Access Compliance Report

Public Rights-of-Way

Intersection ID: 24119	Main Street: LIVINGSTON_MILL_RD	Cross Street: LONGHEDGE_LN	Location: NE
ADA ID: 76A599D83F32	Ramp Type: PerpDiag	Initial Pass/Fail: Fail	Overall Compliance: No
Severity Score: 25			
Codes/Mitigation Info/Possible Solution		Field Measurements/Component Compliance

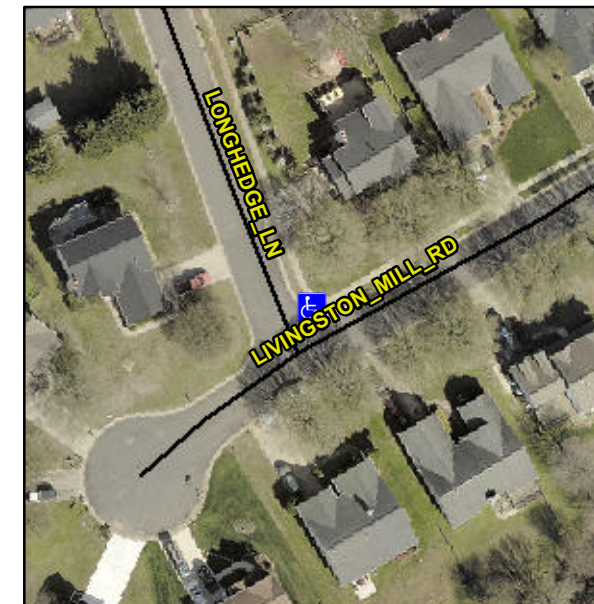
R304.2.2, R304.5.3

Compliance	Description	Data	Compliance	Description	Data
N/A	Ramp Length (in)	93.0	No	Ramp Slope (%)	10.9
Yes	Ramp Width (in)	48.0	No	Ramp XSlope (%)	5.5
N/A	Flare Type LT	N/A	N/A	Flare Type RT	N/A
N/A	Flare Slope LT (%)	N/A	N/A	Flare Slope RT (%)	N/A
N/A	Flare Traversable LT?	N/A	N/A	Flare Traversable RT?	N/A
N/A	Landing Length (in)	N/A	N/A	DWS Provided?	N/A
N/A	Landing Width (in)	N/A	N/A	DWS Contrast?	N/A
N/A	Landing Slope (%)	N/A	N/A	DWS Length (in)	N/A
N/A	Landing X Slope (%)	N/A	N/A	DWS Full Width?	N/A
N/A	Landing Curb? (Y/N)	N/A	N/A	DWS Offset (in)	N/A
N/A	Shared Landing?	N/A			
N/A	Gutter Ponding?	N/A	N/A	Gutter Slope (%)	N/A
N/A	Gutter Lip Ht (in)	N/A	N/A	Gutter X Slope (%)	N/A
N/A	Painted X Walk1?	No	N/A	Painted X Walk2?	No
	X Walk 1 Direction	To SW		X Walk 2 Direction	To S
N/A	X Walk 1 Width (in)	N/A	N/A	X Walk 2 Width (in)	N/A
	X Walk 1 Slope (%)	4.2		X Walk 2 Slope (%)	3.8
	X Walk 1 X Slope (%)	4.6		X Walk 2 X Slope (%)	4.4

Remove & Replace Curb Ramp With Two New Directional Ramps or Equivalent.
